PRODUCT RECALL NOTICE: KD Model Trailers

Dear RACKandROLL Trailer Owner:

Fig. A - Center Rail with Original Safety Bracket Installed

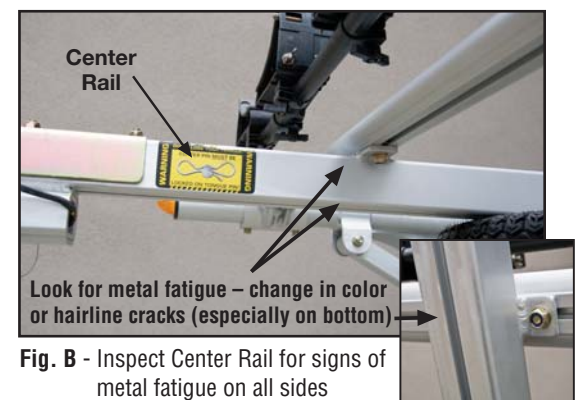
1. Confirm that the Original Safety Bracket is installed (*see fig. A*).
2. Inspect the Center Rail for bending, cracking, or signs of metal fatigue before using (*see fig. B*). Discontinue use of the trailer if you see any of the above warning signs and contact us immediately.
3. Never exceed the load limit of 250 pounds and follow the safety checklist.

In first quarter of 2008 we will provide you with a steel insert that must be installed in your Center Rail. The work will take approximately 30 minutes. **To obtain your free SAFETY UPGRADE KIT, contact RACKandROLL toll-free at 888-935-9350.** The Safety Upgrade Kit can be sent to you or your dealer. If you do the work, we will reward you. Or we will find a dealer or service technician to do it for you. If you no longer own this trailer, please call and tell us.
